PLANNING COMMISSION MEETING

**WHITE LAKE TOWNSHIP
PLANNING COMMISSION
SEPTEMBER 17, 2026**

RE: Ginko Self Storage -Final Site Plan/Final Engineering Plan Review-4th Review
~~Stormwater Maintenance Agreement Review-1st Review~~

Revised Final Site Plan Review for Special Land Use for White Lake Charter Township, Michigan

LB 15 - LB 3 PROFILE

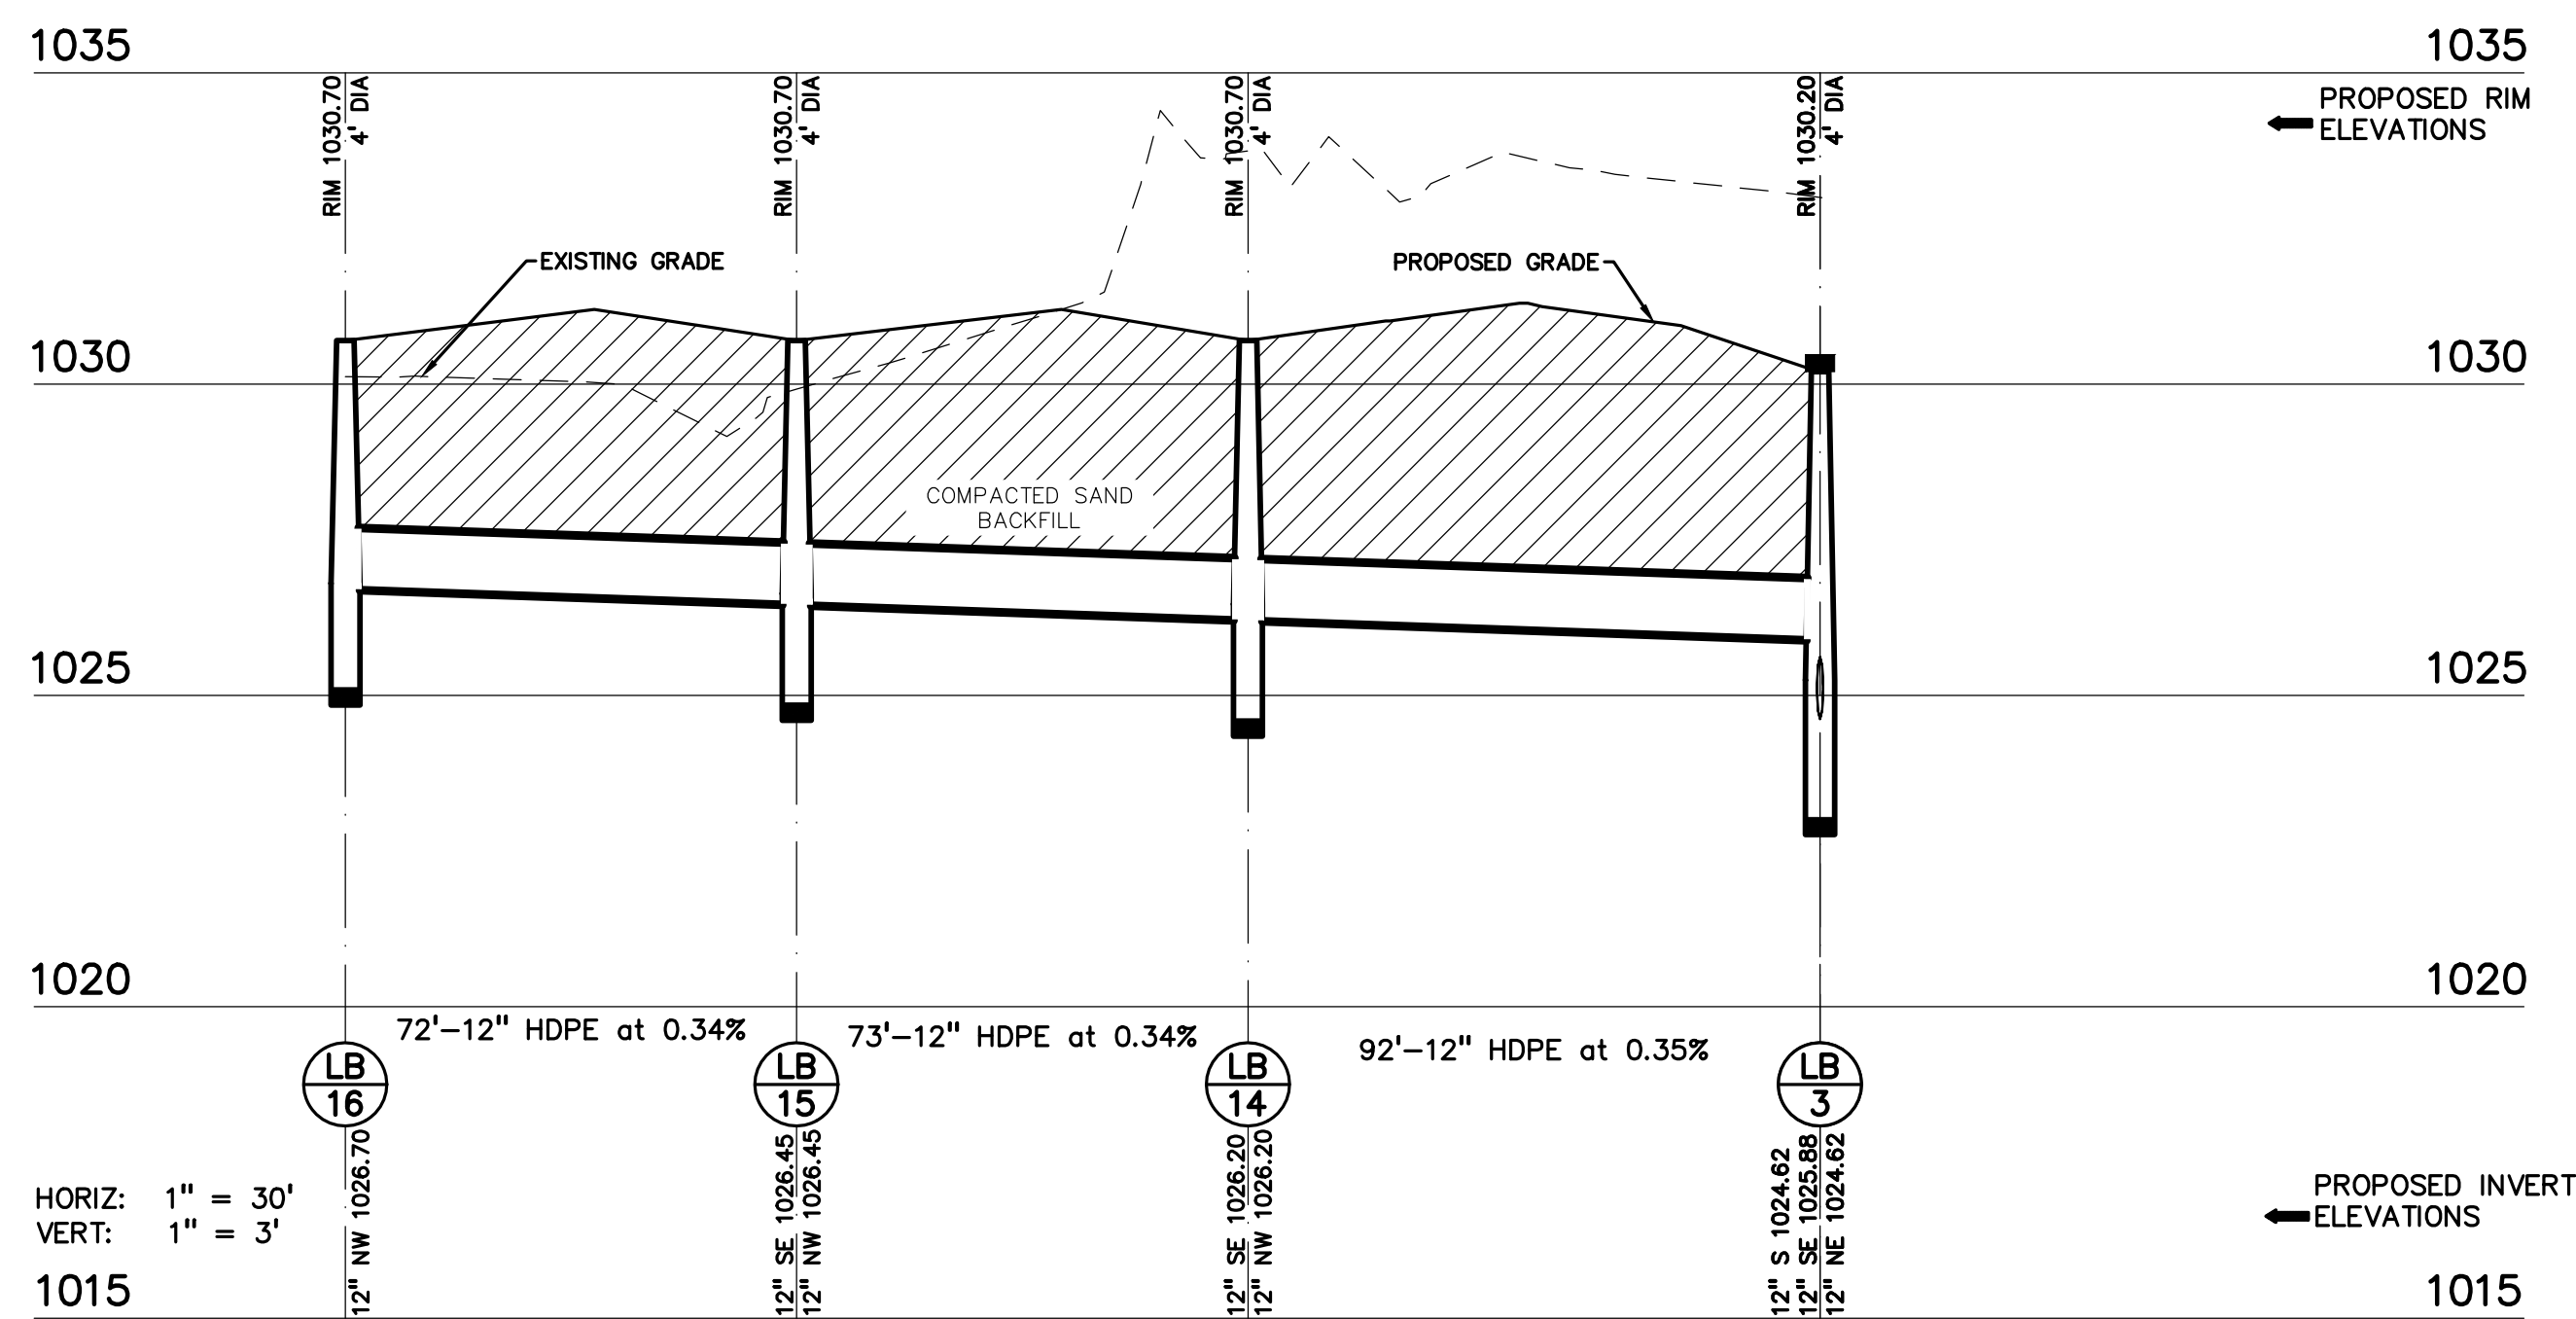
3. Sheet C-7.0- It appears that profiles were not updated based on revised storm sewer structure rim and invert elevations. We have attached a red lined copy of this sheet.

A-1.0

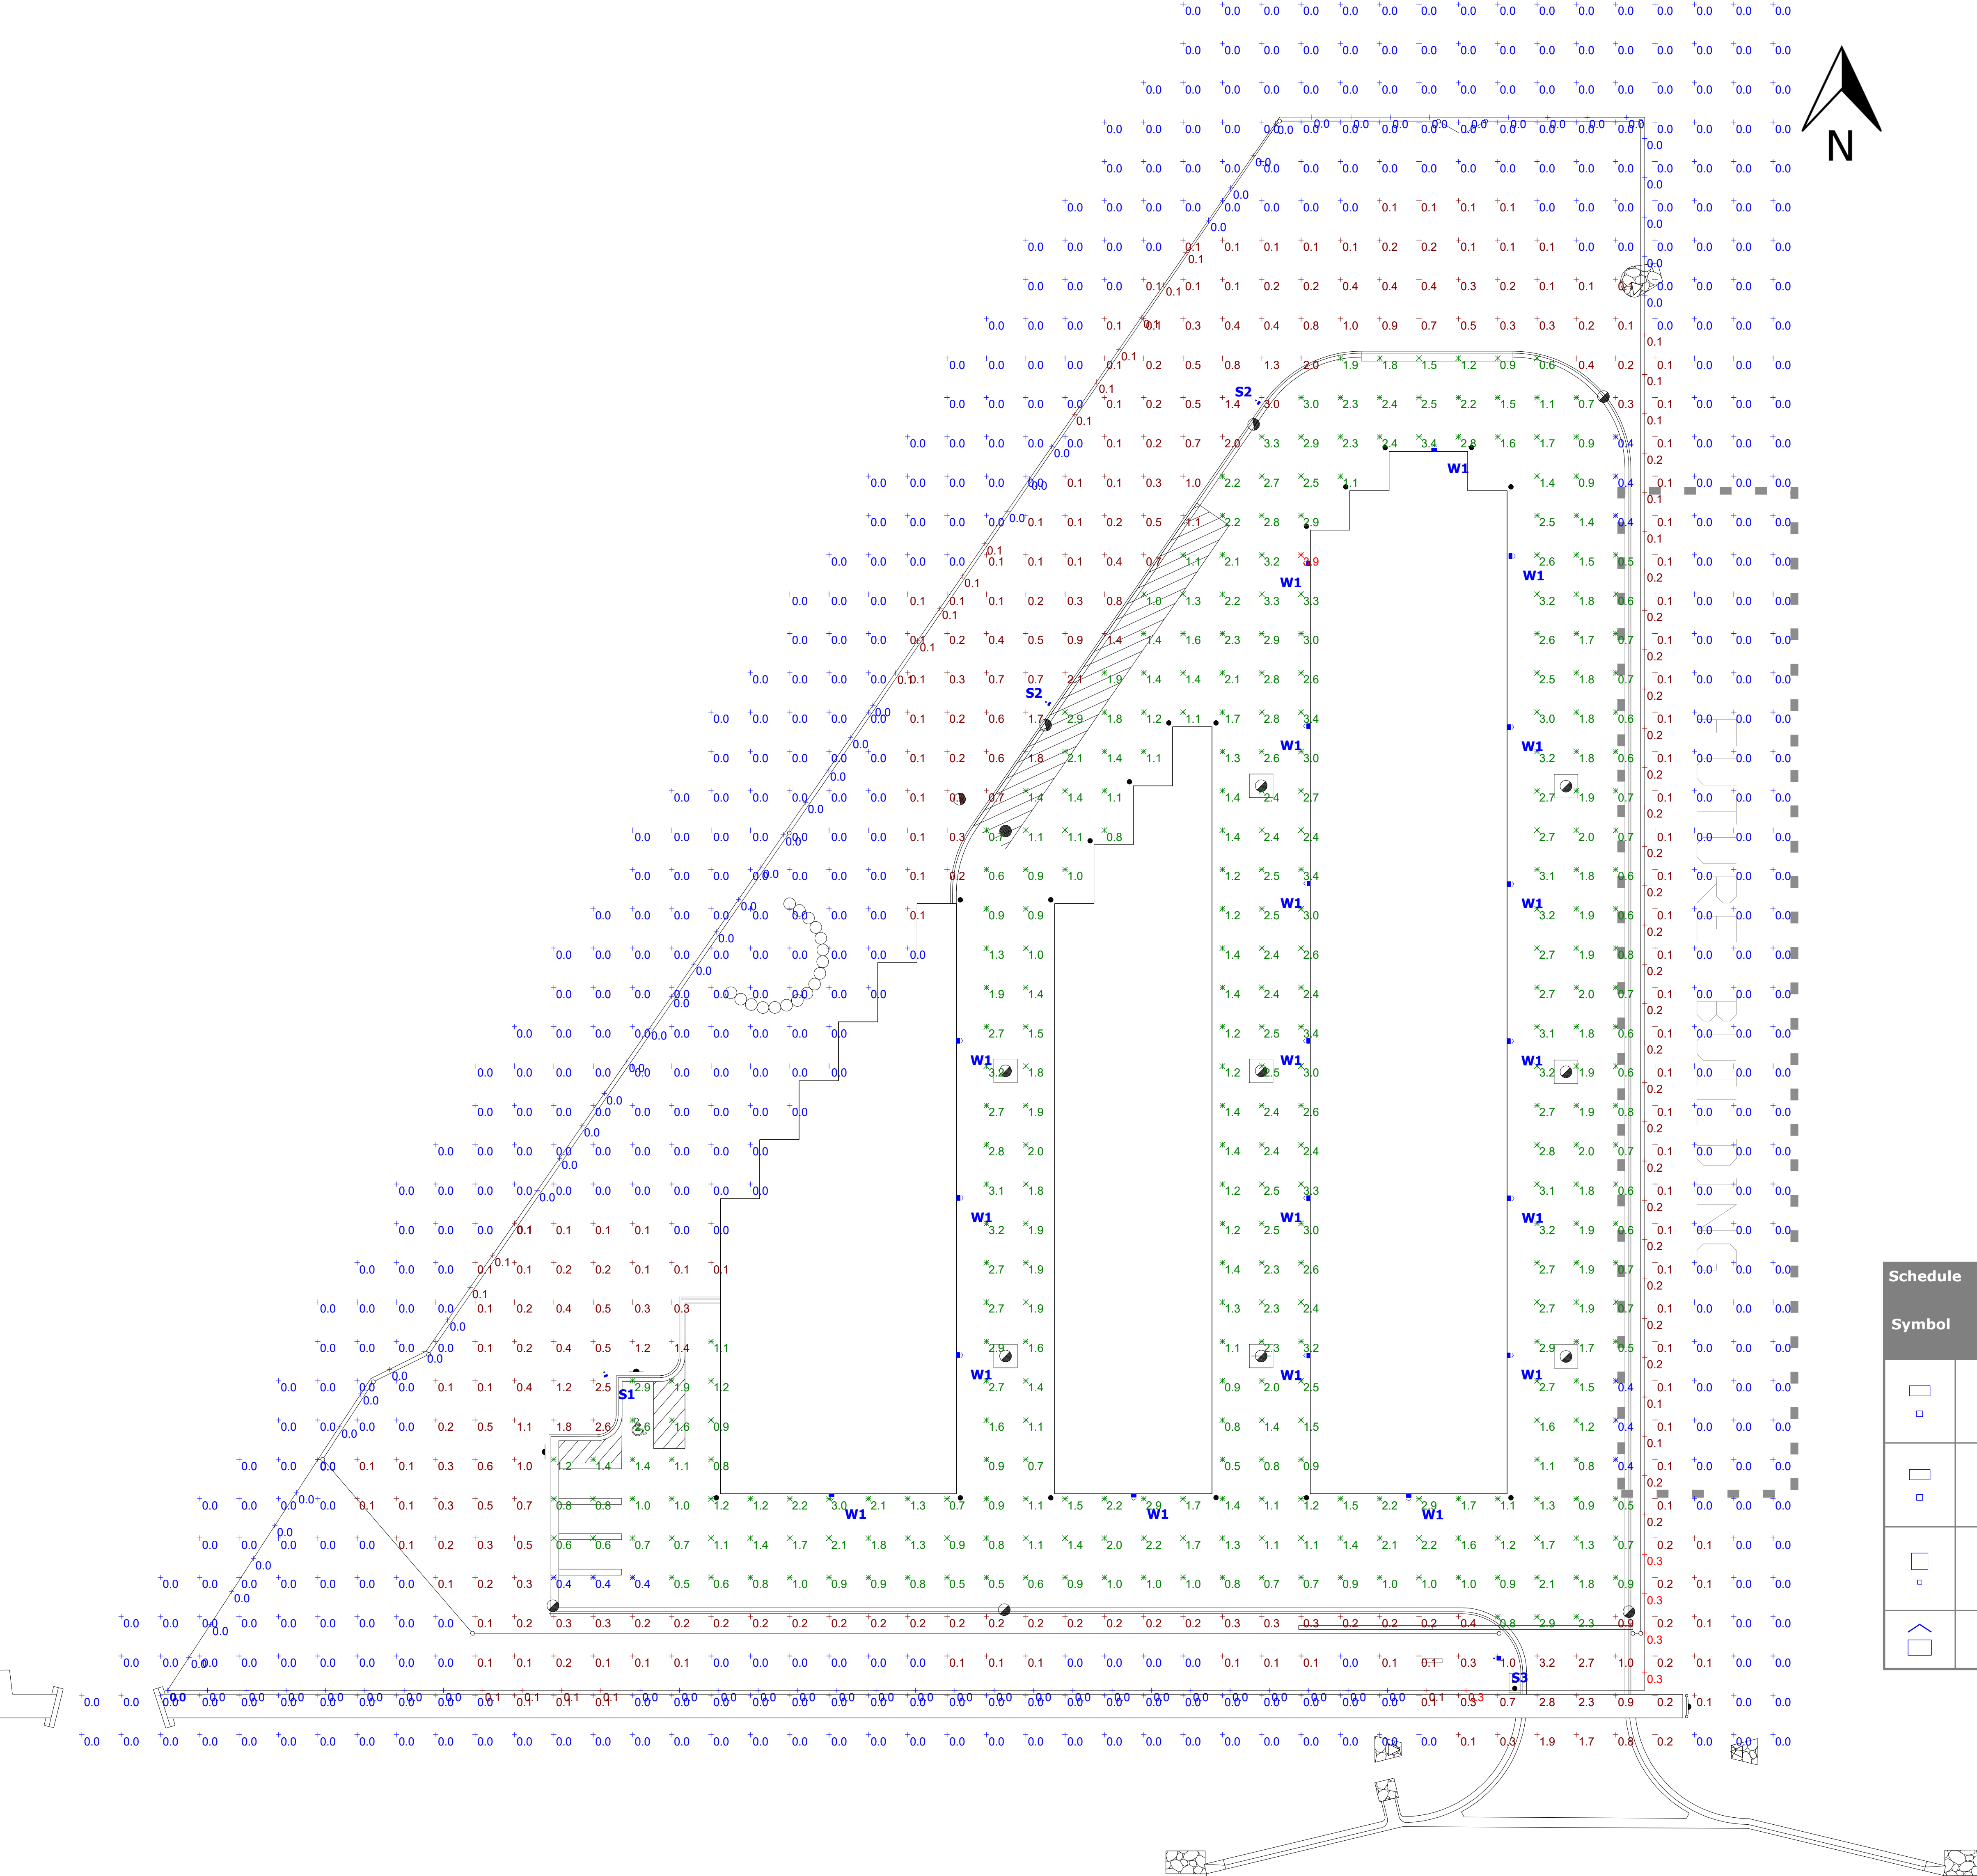
Architectural information required at final site plan review includes the types of facing materials to be used on structures. Sheet A-1.0 indicates all elevations will be faced with metal panels, steel roll up doors, and common brick with limestone caps. The sheet also provides floorplans for all three buildings. Buildings 1 and 2 remain the same, however building 3's size and layout have been modified. The building is now 12,850 sqft, down from the originally approved 15,300 sqft. All storage units are proposed to be accessed from the exterior as opposed to an interior hallway.

Items to be Addressed: *Exterior construction material sample boards and colored elevations shall be provided for Building Official and Planning Commission review.*
